Project number and name or topic: 5056 – Tank 8 Internal Inspection Review

Crude Oil Storage Tank 8 Maintenance Review

PWSRCAC Contract # 5056.20.01

April 2021

Figure 6 - Predicted Minimum Remaining Floorplate in 2023

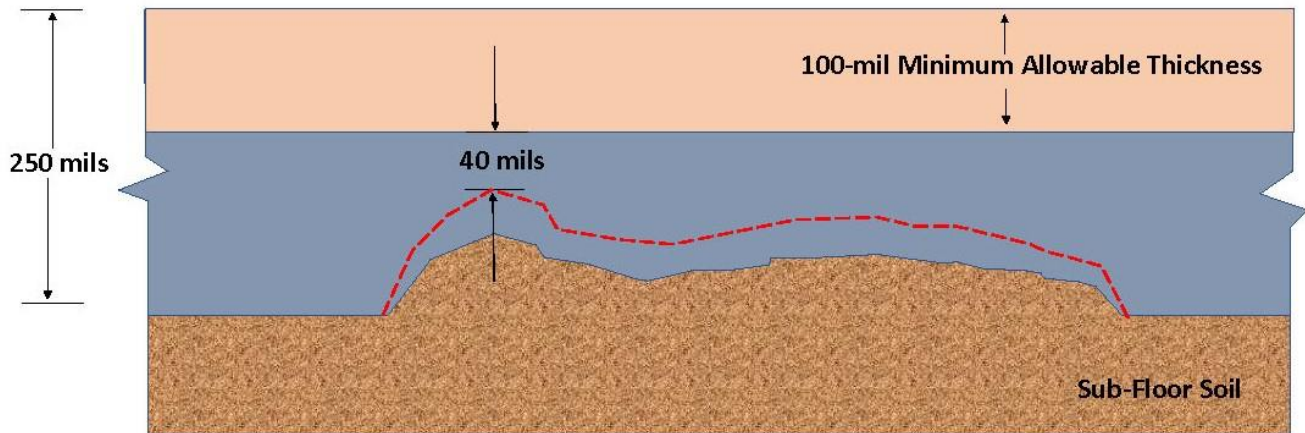
The actual corrosion rate experienced on the tank floor is closer to 11 mils-per year. The red dotted line in Figure 6 depicts the probable deepest pitting in the floorplate that will exist in 2023 (approximately 140-mils remaining wall thickness). The beige area represents the 100-mil minimum allowable floorplate thickness after the service interval.

APSC's approach to the 2020 return-to-service is relatively conservative. The assumed corrosion rate of the service interval calculations is significantly higher than the measured rate. There is very little risk of a corrosion failure from Tank 8 before the tank is removed from service again in 2023.

Figure 8 - Annular Plate Extension (No Seal)

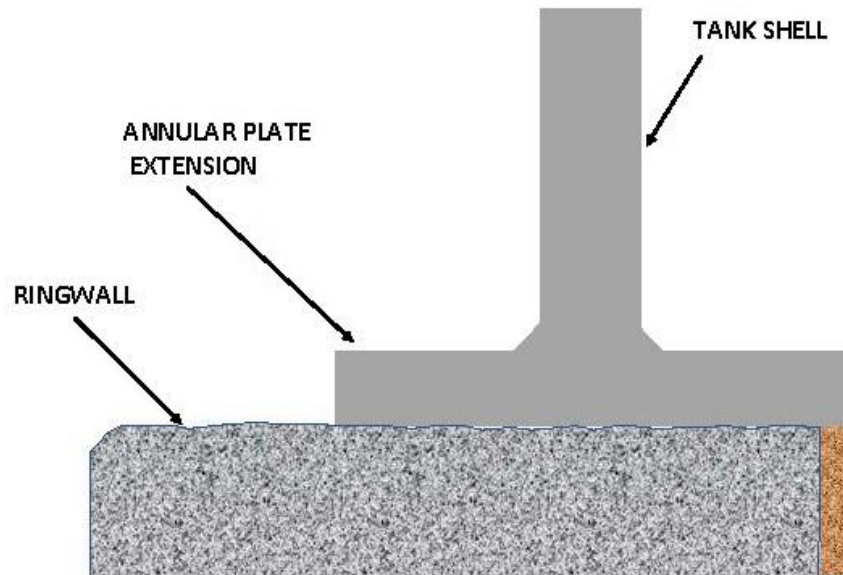
Figure 8 represents an enlarged section view of the area in the red circle from Figure 7. The tank annular plate extension (or floorplate extension) rests directly on top of the concrete ringwall. The floorplate extension is not sealed to the concrete ringwall. Any rainwater running down the side of the tank can collect on the top of the ringwall and either run off the outer diameter of the foundation or seep under the annular plate extension and into the soils between the floorplate and secondary containment liner. This can exacerbate corrosion of the tank

floor and potentially lead to buoyancy forces pushing up on the tank floor and damaging it and/or the tank roof column supports – which is discussed in detail later.

The seals between the VMT tank annular plate extensions and the concrete ringwalls are still not maintained. Figure 10 is a photo depicting the condition of the Tank 8 annular plate extension/ringwall seal in 2019-2020. It is obvious from the photo that the seal has failed and is no longer preventing water from seeping beneath the tank floor.

Most operators seal between the annular plate extension and the concrete ringwall to prevent rainwater from migrating beneath the tank and increasing the risk of corrosion (shown in Figure 9). Operators typically use a flexible industrial grout to seal this joint in the manner shown below. Differential movement between the steel annular plate extension and the concrete ringwall may damage the seal so it requires frequent inspection and repair. In the 1980s APSC deemed that the seals were not critical and made the decision to allow them to degrade rather than to incur the continued cost to maintain them.

Figure 11 – Cracked Ringwall/Annular Plate Seal

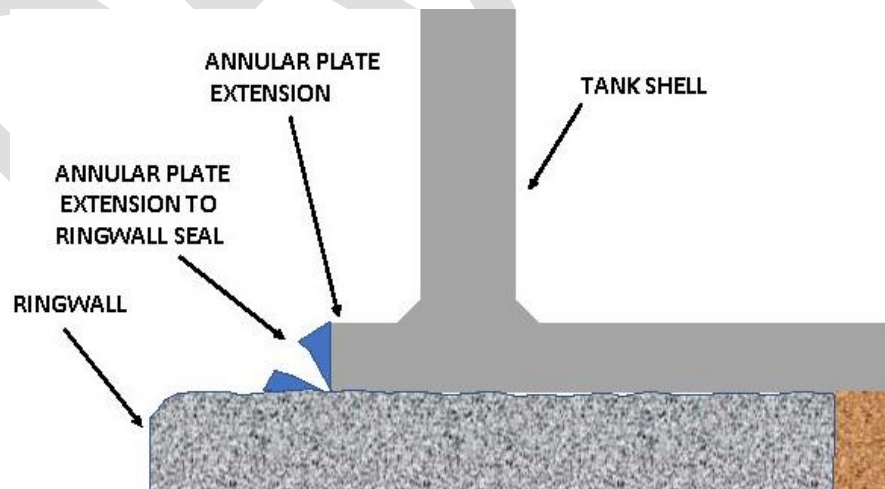
Rather than preventing water from seeping beneath the tank floor, the cracked seals may be exacerbating the water migration into that area. Figure 11 depicts a section of the ringwall/annular plate with a cracked seal. The presence of a crack in that joint forms a gap that may funnel more rainwater beneath the floor than would be caused by the lack of any seal.

Figure 12 – Tank Sump Flotation

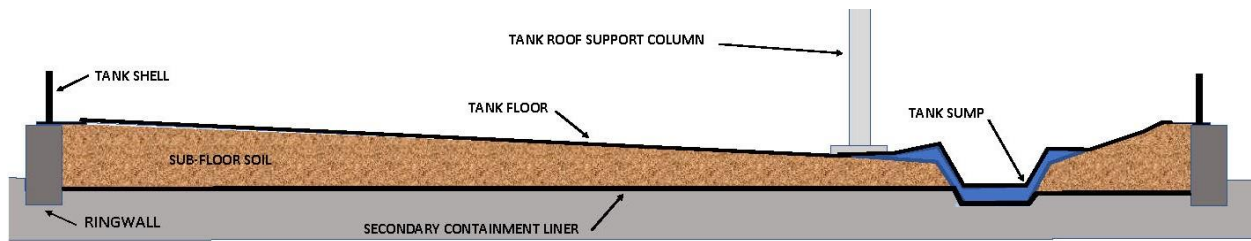
Water-saturated soils beneath the crude tanks increase the risk of bottomsides corrosion and impart buoyant (upward) forces on the tank sump and surrounding floorplate. When the tank is fully emptied of oil, these forces can cause the sump to float and be displaced vertically (Figure 12). There are four roof support columns in relatively close proximity to the sump. Any upward motion of the sump can cause high stresses on the adjacent columns, risking damage to the floor or column footing.

Figure 13 – Subfloor Drainage System Location

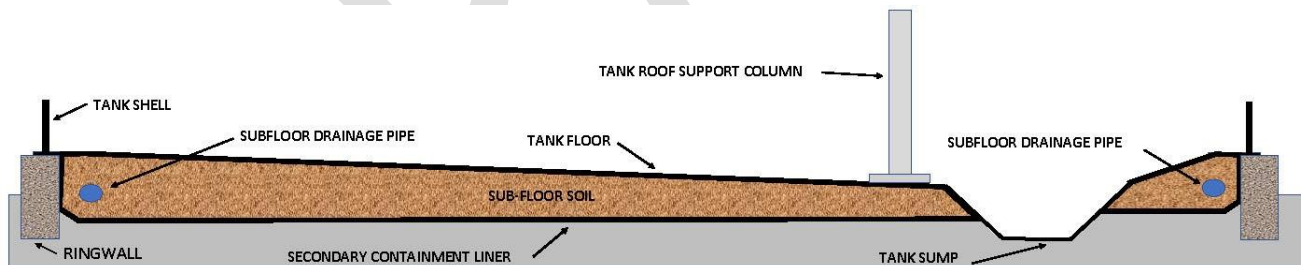
On some of the crude storage tanks, APSC installed subfloor drain piping between the tank floor and secondary containment liner (Figure 13). We have not received a record of exactly which tanks have that drainage system. However, the drain piping was installed at a level that is significantly higher than the bottom of the tank sump. While the drain piping will reduce the buoyant forces acting on the sump, it will not totally alleviate those forces.

- A. Use the existing drainage systems and CP monitoring tubes to remove as much accumulated water as possible from between the floorplate and secondary containment.
- B. Maintain inventory in the crude tanks to at least 1 foot of depth at the perimeter until more detailed assessments on subfloor water accumulation can be completed on each tank. This will overcome potential buoyant forces on the sumps under the worst-case scenario.
- C. Replace and maintain the seals between the tank annular plate extensions and the ringwalls to prevent future water migration into the tank subfloor areas.

Figure 17 – 2001-2006 Average Change in Tank 8 Depolarized Potential Readings

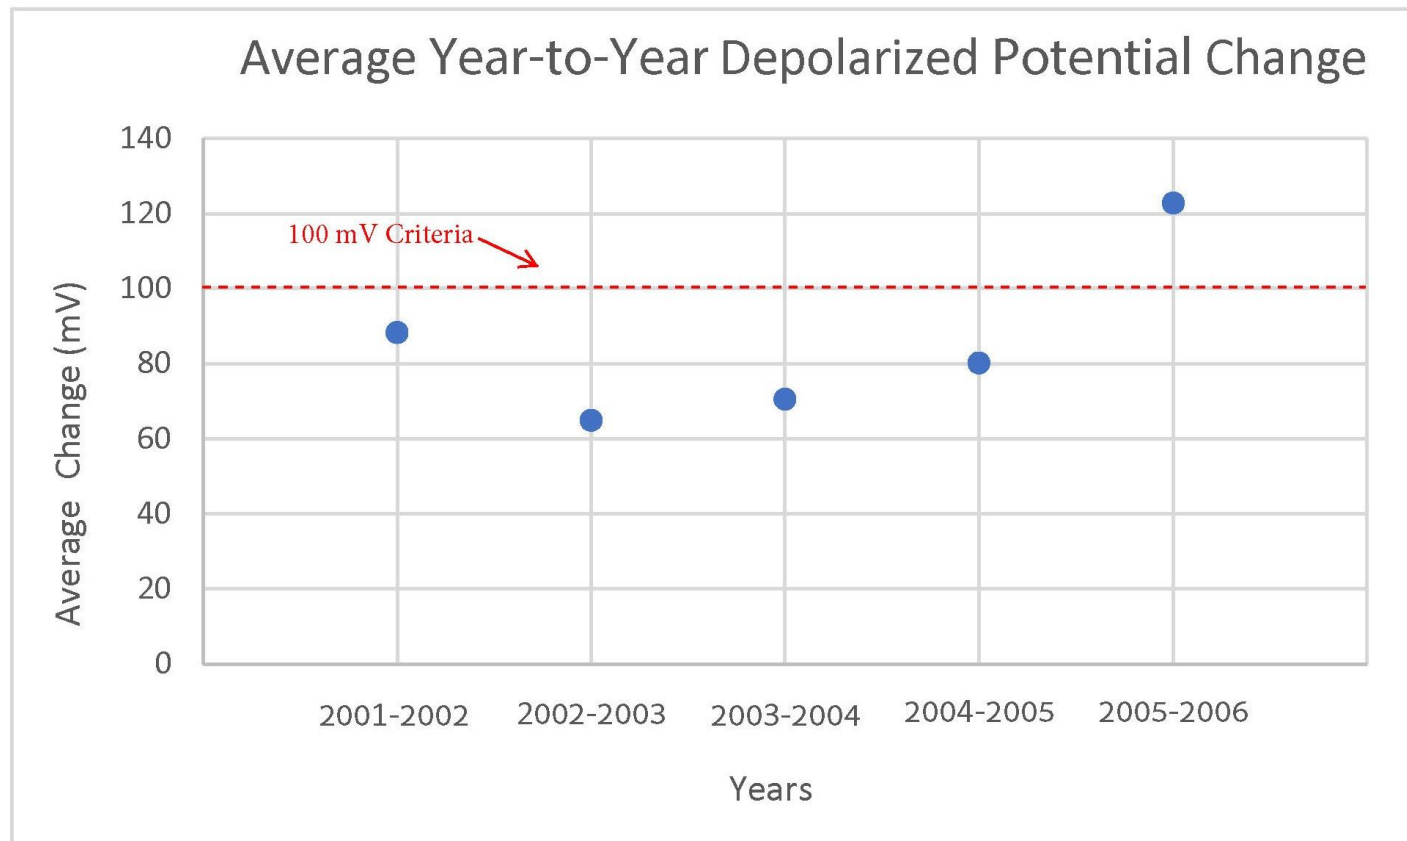
Figure 17 presents a graph of the 2001-2006 year-to-year average change in depolarized potentials for Tank 8. A line showing the 100 mV criteria was added to the graph for reference. This clearly illustrates that the annual changes in the depolarized potentials on the tank are similar in magnitude to the criteria that is being measured against. In fact, between 2005 and 2006, the average change in depolarization potentials was greater than the 100 mV criteria that is being measured against.

The depolarized potential is used (with the instant off potential) to ascertain if the structure has 100 mV of polarization. These year-to-year changes in the depolarized readings on Tank 8, clearly illustrate why the standard requires that the operator measure the formation or decay or polarization each year. This data provides clear, empirical evidence that the practice of using depolarized data from past years will result in errors and invalid CP data. This supports the NACE SP0169 requirement that the formation or decay of polarization be measured in order to utilize the 100 mV criteria. The depolarized readings should be collected in the same relative timeframe (within weeks) of the collection of instant off or IR-free data.

- B. APSC should collect depolarized data each year for areas not meeting the -850 mV criteria for CP. They should stop using old, depolarized data. The Tank 8 depolarized data provided in Section 3.4.1, shows that the depolarized potentials for a structure vary greatly from year-to-year. The use of depolarized data from prior years introduces a significant error into the measurement of polarization.

Figure 18 – Subfloor Anode/Monitoring Tube Locations

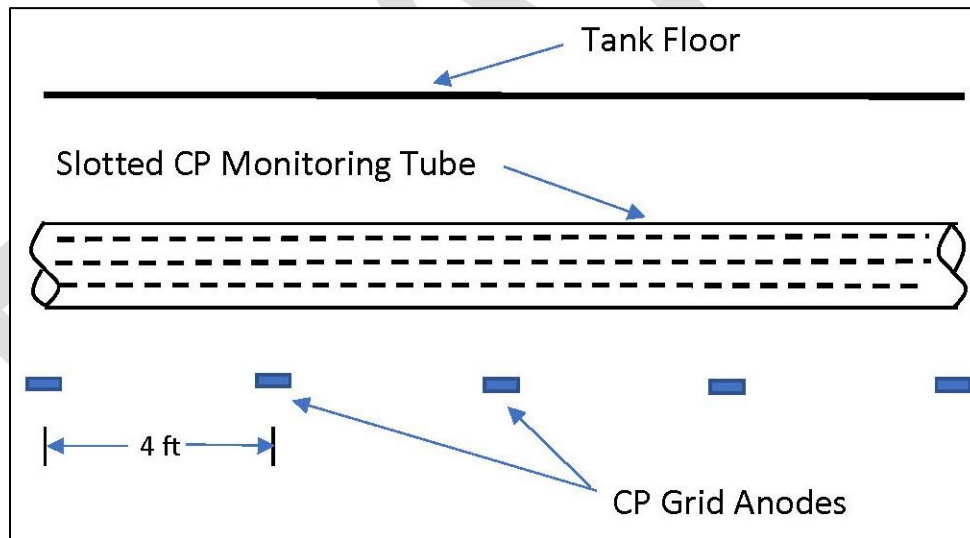
Regardless of the cause of the error, this statement is basically saying that the very negative readings include an inherent error and are invalid. If the proximity to the anode grid wires was the cause of the error as suggested by the APSC, then to collect accurate data, the operator would have to know precisely where the reference cell was in relation to each anode grid wire and they also would have to determine the minimum distance between the reference cell and anode grid wire that is necessary to collect accurate data. Figure 18 (below) is intended to depict the relative locations between the MMO anode grid wires, the slotted CP monitoring tube, and the floorplate. The CP reference cell is run beneath the tank through the slotted CP monitoring tube and data is collected at set distances from the tank shell. As can be seen from Figure 18, the reference cell will always be within 2-feet of the anode.

Figure 19 – CP Reading Error/Distance from Anode

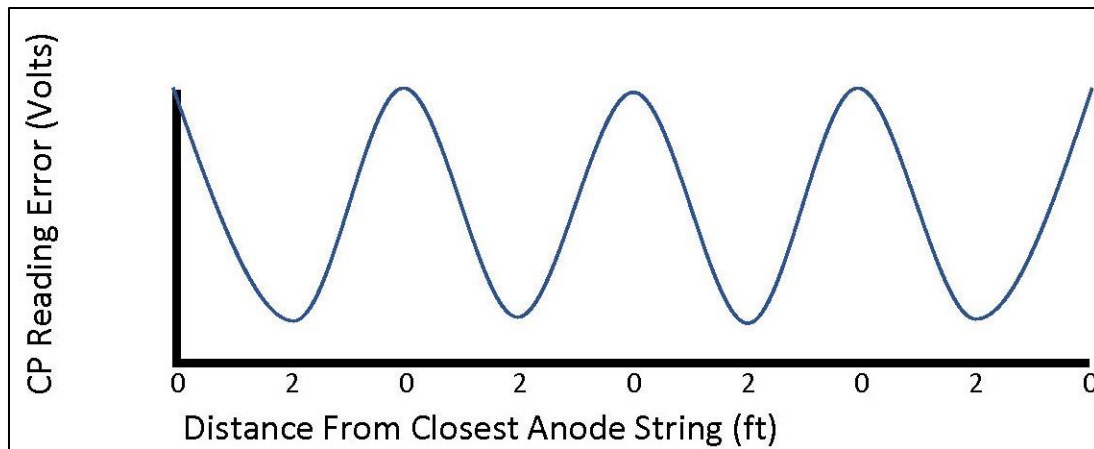
If the CP reading errors were caused by proximity to the anodes, then the magnitude of that error would gradually decrease as the distance from the anode increases. This decrease would continue until the reading was taken at the midpoint between two anode wires (as depicted in Figure 19), at which point the error would begin to increase again. If APSC's statement regarding proximity to the anode is accurate, this means that all CP readings collected beneath the tank are likely to be impacted by the same causal error, although the magnitude of that error may vary relative to the distance from the anode.

In our professional opinion, the reasoning for the error that is cited may not be entirely correct. If all impacting CP systems are properly interrupted, then the field around the anode should collapse and the potential readings should not be impacted by the relative proximity to the anode.

Figure 21- Tank 8 Repair Patch Locations

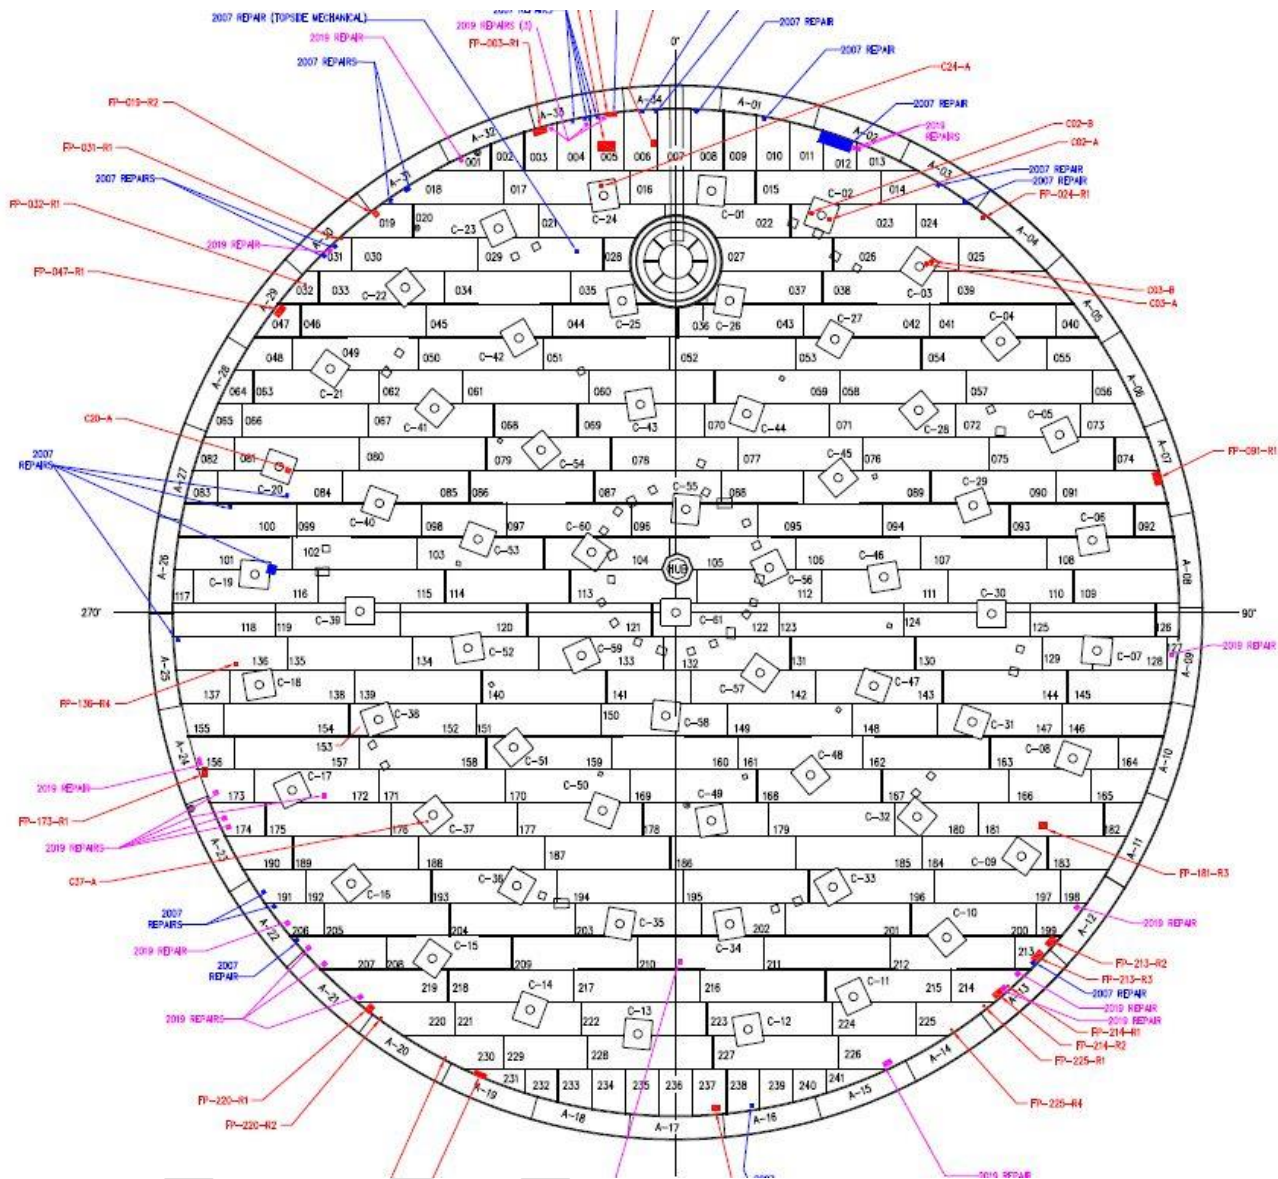
The tank CP system design does not appear to have maintained a consistent distance between the tank floor and the anode grid. The anode material was to be maintained at least 18 inches from the annular plate and at least 12 inches from the sump.⁸ The inconsistent anode offset from the floor makes maintaining even current distribution across the floor much more difficult. This configuration would suggest that the CP current density afforded the outer perimeter floor plates would be roughly 50% lower than the CP current density afforded the floorplates near the sump.

The design also did not include the installation of CP ribbon beneath the annular plate. That suggests that some of the current intended to protect the perimeter floorplate will instead be picked up by the annular plate, further reducing the protection of the perimeter floorplates.

This may be in part why the majority of the floorplate repairs completed in 2007 and 2019 were located on the perimeter plates of Tank 8 (Figure 21).

- A. The replacement cathodic protection system should include a groundbed that is a consistent distance from the floorplate to ensure more uniform distribution of CP current.
- B. The replacement CP system should also have the ability to adjust the groundbed circuit resistances or driving voltage, in perimeter areas, so that the levels of CP current can be balanced across all areas of the tank floor. This can be done with the installation of a separate groundbed and rectifier in the perimeter areas.
- C. CP monitoring tubes beneath the tanks should be slotted through the area beneath the annular plate so that levels of CP in those areas can be adequately monitored.
